Access Compliance Report

Public Rights-of-Way

Intersection ID: 2927	Main Street: DOWNFIELD_WOOD_DR	Cross Street: RIDGEFIELD_DR	Location: NE
ADA ID: 2B0D8FAC5960	Ramp Type: Perp	Initial Pass/Fail: Fail	Overall Compliance: No
Severity Score: 8.75			
Codes/Mitigation Info/Possible Solution		Field Measurements/Component Compliance

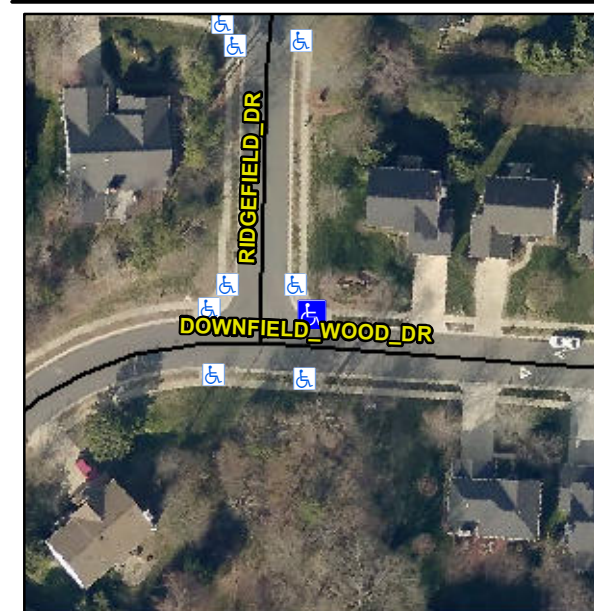
Not Found, R304.5.1

Compliance	Description	Data	Compliance	Description	Data
N/A	Ramp Length (in)	49.0	Yes	Ramp Slope (%)	7.0
No	Ramp Width (in)	38.0	Yes	Ramp XSlope (%)	0.9
N/A	Flare Type LT	N/A	N/A	Flare Type RT	N/A
N/A	Flare Slope LT (%)	N/A	N/A	Flare Slope RT (%)	N/A
N/A	Flare Traversable LT?	N/A	N/A	Flare Traversable RT?	N/A
N/A	Landing Length (in)	N/A	N/A	DWS Provided?	N/A
N/A	Landing Width (in)	N/A	N/A	DWS Contrast?	N/A
N/A	Landing Slope (%)	N/A	N/A	DWS Length (in)	N/A
N/A	Landing X Slope (%)	N/A	N/A	DWS Full Width?	N/A
N/A	Landing Curb? (Y/N)	N/A	N/A	DWS Offset (in)	N/A
N/A	Shared Landing?	N/A			
N/A	Gutter Ponding?	N/A	N/A	Gutter Slope (%)	N/A
N/A	Gutter Lip Ht (in)	N/A	N/A	Gutter X Slope (%)	N/A
N/A	Painted X Walk1?	No	N/A	Painted X Walk2?	N/A
	X Walk 1 Direction	To S		X Walk 2 Direction	N/A
N/A	X Walk 1 Width (in)	N/A	N/A	X Walk 2 Width (in)	N/A
	X Walk 1 Slope (%)	3.4		X Walk 2 Slope (%)	N/A
	X Walk 1 X Slope (%)	1.8		X Walk 2 X Slope (%)	N/A

Remove & Replace Entire Ramp.
